**Global Forum for Road Traffic Safety****Group of Experts on Road Signs and Signals****Seventeenth session**

**Programme of Work: Taking Stock of National Legislation****Review of recommendations on A through F signs****Draft final report****Submitted by the secretariat****I. Background**

**A, 19 a “INTERSECTION WITH A ROAD THE USERS OF WHICH MUST GIVE WAY”**

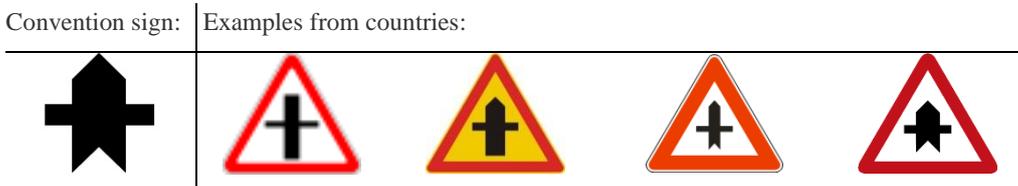
Some countries do not use the arrow head or the “V” shape at the bottom. The Group recommended using the symbol in the Convention without altering it (that is, having the arrow head and the “V” shape at the bottom). The Group clarified that the arrow head and the “V” shape at the bottom, and the differences in the proportion of the line widths, are essential characteristics of the symbol.

**A, 19 b “INTERSECTION WITH A ROAD THE USERS OF WHICH MUST GIVE WAY”**

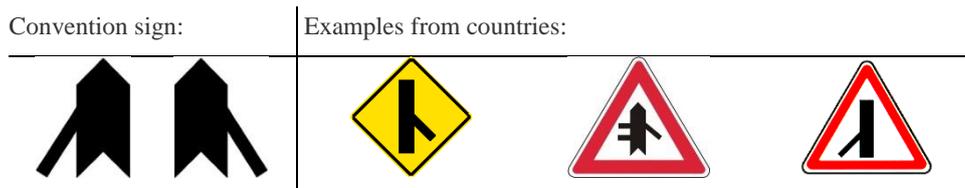
Some countries do not use the arrow head or the “V” shape at the bottom. The Group recommended using the symbol in the Convention without altering it (that is, having the arrow head and the “V” shape at the bottom). The Group clarified that the arrow head and the “V” shape at the bottom, and the differences in the proportion of the line widths, are essential characteristics of the symbol.

**A, 23 “TWO-WAY TRAFFIC”**

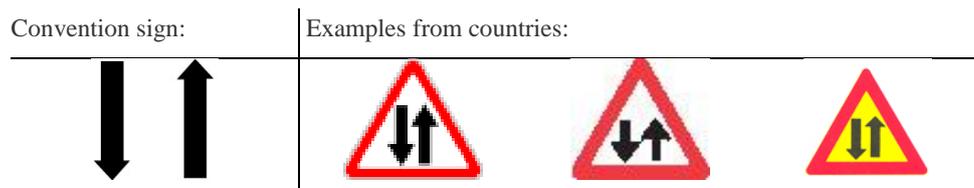
The Group recommended that the symbol in the Convention be modified by enlarging the arrow heads. Addressed in chapter 1 – see issue 36

#### A, 24 TRAFFIC CONGESTION

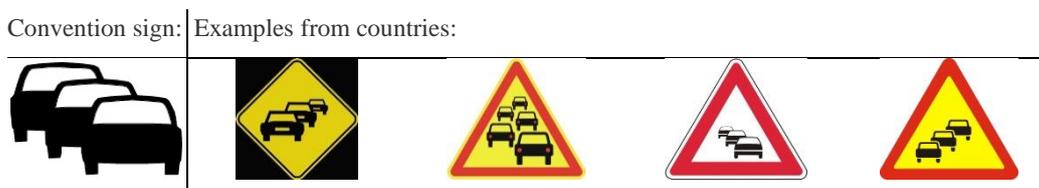
The Group noted that many countries used slightly different symbols and in some cases, more than three vehicles were included in the symbol and the vehicles have red lights. Nevertheless, the Group believed that the essential characteristics of the symbol have been retained.

#### A, 25 “LEVEL CROSSINGS”

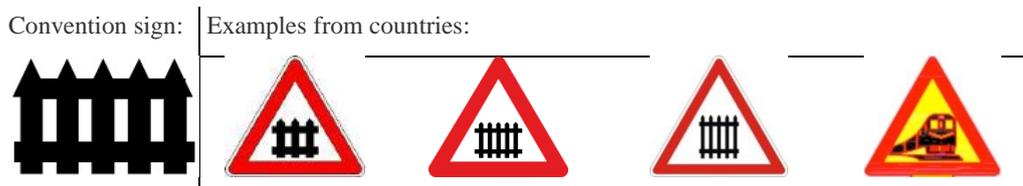
The Group noted that many countries used slightly different A, 25 symbols to indicate a gated level crossing except Nigeria which uses a symbol of a modern train. The Group considers that the train symbol is not in conformity with the Convention. The symbol of a train is to be used for the sign A, 26 a.

**A, 28 a, A, 28 b, A, 28 c “SIGNS TO BE PLACED IN THE IMMEDIATE VICINITY OF LEVEL-CROSSINGS”**

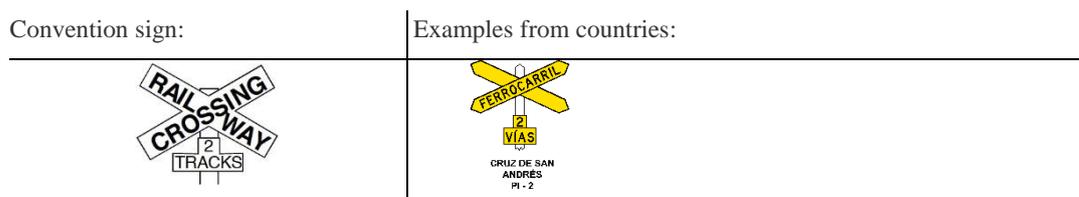
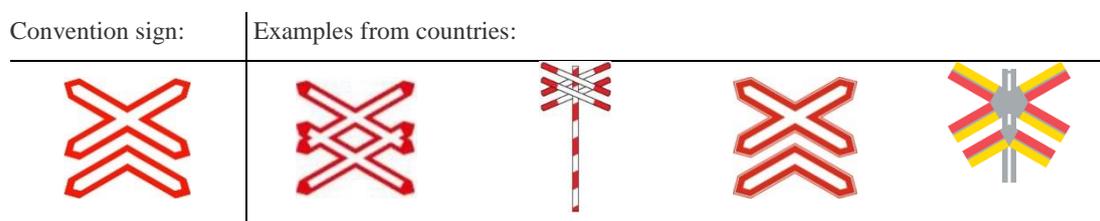
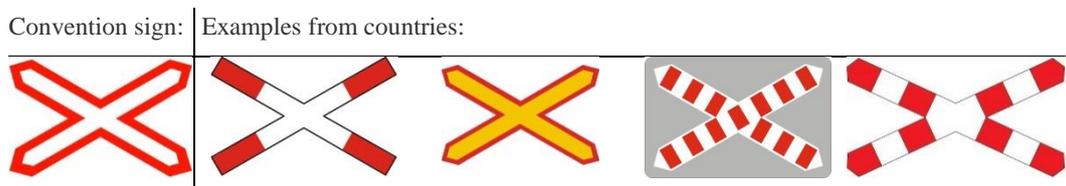
The Group noted that some countries use signs that do not appear to be in conformity with the Convention.

The Group recommended to pair the signs A, 28 a and A, 28 c (with no additional panel) to indicate the immediate vicinity of railway line with one track and to pair the signs A, 28 b and A, 28 c (with additional panel) to indicate the immediate vicinity of railway line with at least two tracks.

### B, 3 “PRIORITY ROAD”

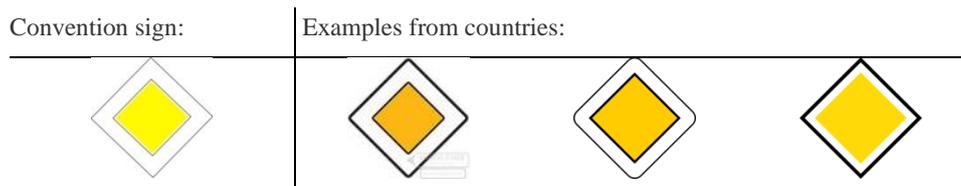
The Group noted that some countries do not use the black narrow strip for the yellow or orange square in the centre, and recommended that they do so. ~~The Group further recommend that the orange colour option for inside square be removed.~~

### B, 4 “END OF PRIORITY”

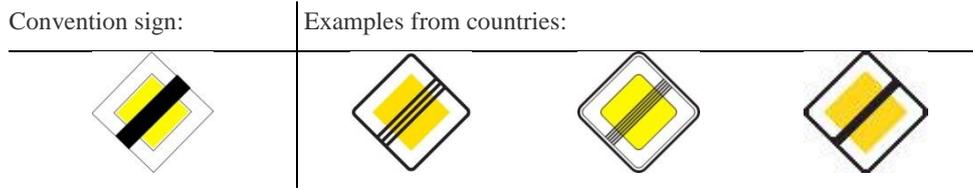
The Group noted that some countries do not use the black narrow strip for the yellow or orange square in the centre, and recommended that they do so. ~~The Group further recommend that the orange colour option for inside square be removed.~~

The Group recommended to amend the definition of sign B, 4 as follows:

**B, 5 “PRIORITY FOR ONCOMING TRAFFIC”**

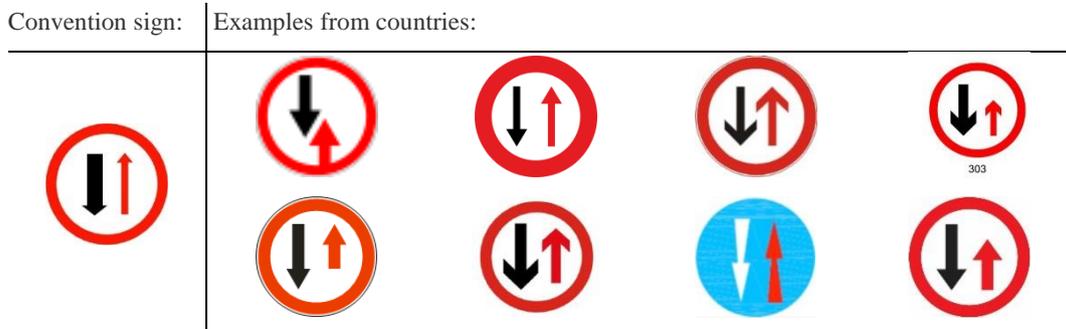
The Group noted that some countries do not use the arrows (i.e. length, width, positioning) as they appear in the Convention. The Group recommended that the arrowheads in the symbol used in Annex 3 of the Convention be enlarged and that the arrows are of the same width. The Group also recommended that the following additional words be inserted at the start of the article related to sign B, 5: “The sign indicating priority for oncoming traffic shall be sign B, 5.” The Group further agreed that an alternative design option should be added for this sign following the Lithuanian example. Addressed in in chapter 1 – see issue 10, 11, 34 and 36

**B, 6 “PRIORITY OVER ONCOMING TRAFFIC”**

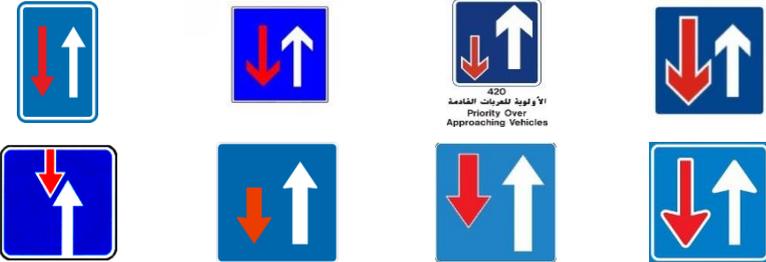
The Group noted that some countries do not use the arrows (i.e. length, width, positioning) as they appear in the Convention. The Group recommended that the arrowheads in the symbol used in Annex 3 of the Convention be enlarged, and that the arrows are of the same width. The Group also recommended that the following additional words be inserted at the start of the article related to sign B, 6: “The sign indicating priority over oncoming traffic shall be sign B, 6.” To assist colour blind drivers, the Group recommended that a white narrow strip should be inserted around the red arrow. The Group further agreed that an alternative design option should be added for this sign following the Lithuanian example. Addressed in in chapter 1 – see issue 10, 11, 34 and 36

**D, 8 “END OF COMPULSORY MINIMUM SPEED”**

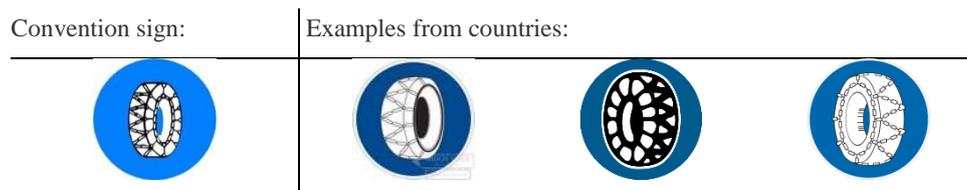
The number should be centred and there should be reasonable amount of distance between the digits (applicable to the Convention’s sign). Addressed in chapter 1 – issue 36

The Group decided that too much space between the digits (i.e., Czech Republic) is not in conformity with the Convention. The red oblique bar should be in front of the number and not behind.

The Group recommended to amend the definition for sign D, 8, as follows: Sign D, 8 "END OF COMPULSORY MINIMUM SPEED", shall mean that the compulsory minimum speed imposed by sign D, 7 is no longer in effect. Sign D, 8 shall to be identical to sign D, 7, except that it shall be crossed by an oblique **an oblique diagonal red bar band or, preferably, red parallel lines forming such a band** running from the upper right edge to the lower left edge sloping down from right to left. **The diagonal red band shall have a white rim to separate the red band it from the blue ground. The diagonal band can be interrupted when crossing the figure specifying the speed. If not interrupted, the diagonal red band shall be placed over the figure.** Addressed in chapter 1 – issue 6 and 11.

**E, 1 c “SPEED LIMITS APPLYING TO DIFFERENT LANES”**

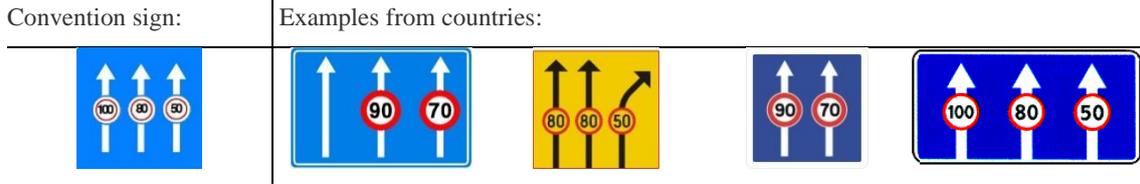
Azerbaijan used a wrong example for E, 1 c sign (truck entry prohibition sign instead of speed limit sign).

The Group recommended that the E, 1 c sign is improved by placing the sign C, 14 on the arrows and adding a white rim.

**E, 2 a “SIGNS INDICATING LANES RESERVED FOR BUSES”**

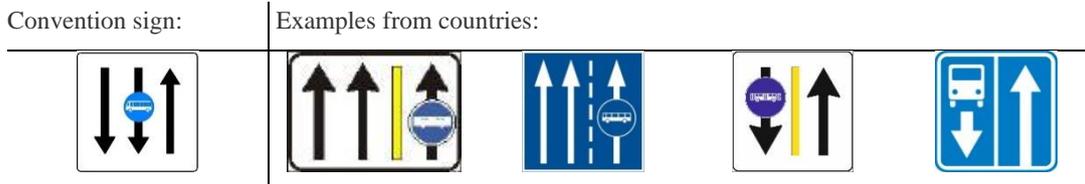
Many countries use road markings (broken or continuous line) on this sign. The Group recommended the symbols on this sign not to include road markings as the arrows indicate the “lanes”.

**E, 2 b “SIGNS INDICATING LANES RESERVED FOR BUSES”**

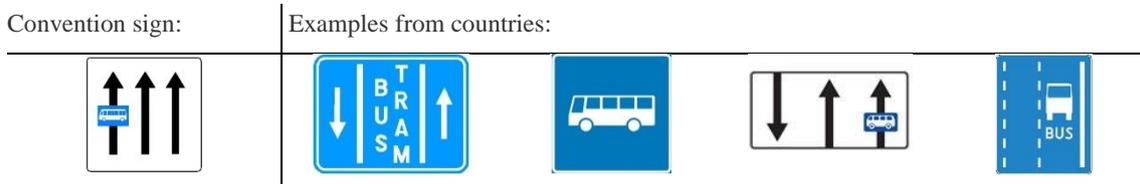
Several countries (Belgium, Croatia, Finland, Latvia, Montenegro, Poland and Ukraine) use examples for E, 2 b that do not correspond to the examples of the Convention.

### E, 5 a “MOTORWAY”

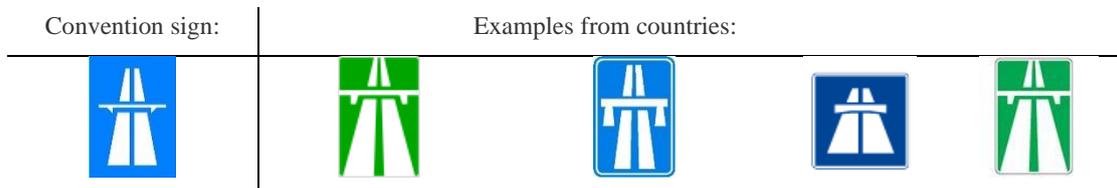
The Group recommended Contracting Parties to pay closer attention to the design details. In particular, the symbol should not touch the edge of the sign (to improve the legibility).

**E, 15 “BUS STOP”, E, 16 “TRAMWAY STOP”**

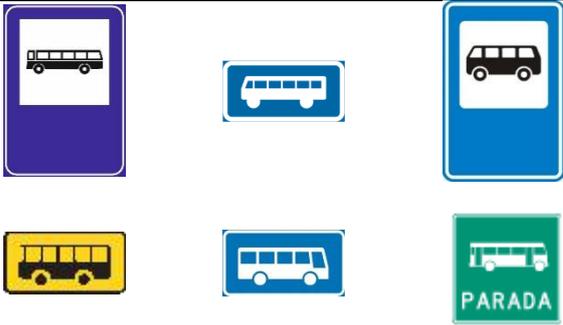
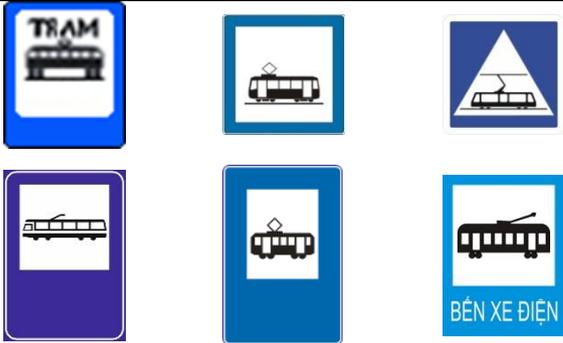
The Group noted that countries use different design variation for E, 15 and E, 16 signs. The Group believed that this is due to the fact that the reproduction (image) of these signs does not follow the description of the general characteristics for E section signs.

**G, 16 “CHAINS OR SNOW TYRES RECOMMENDED”**

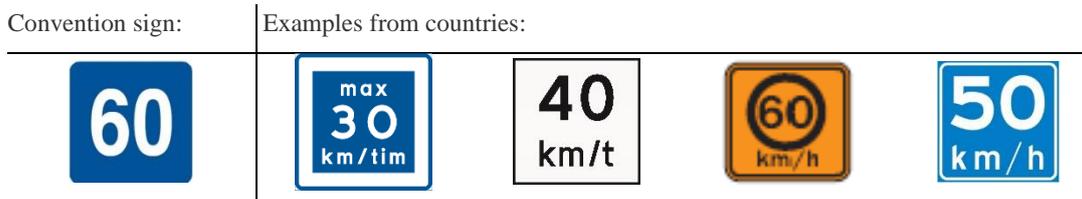
The Group noted that the signs inserted in the RSMS were in conformity with the Convention. No specific observations nor recommendations to Contracting Parties.
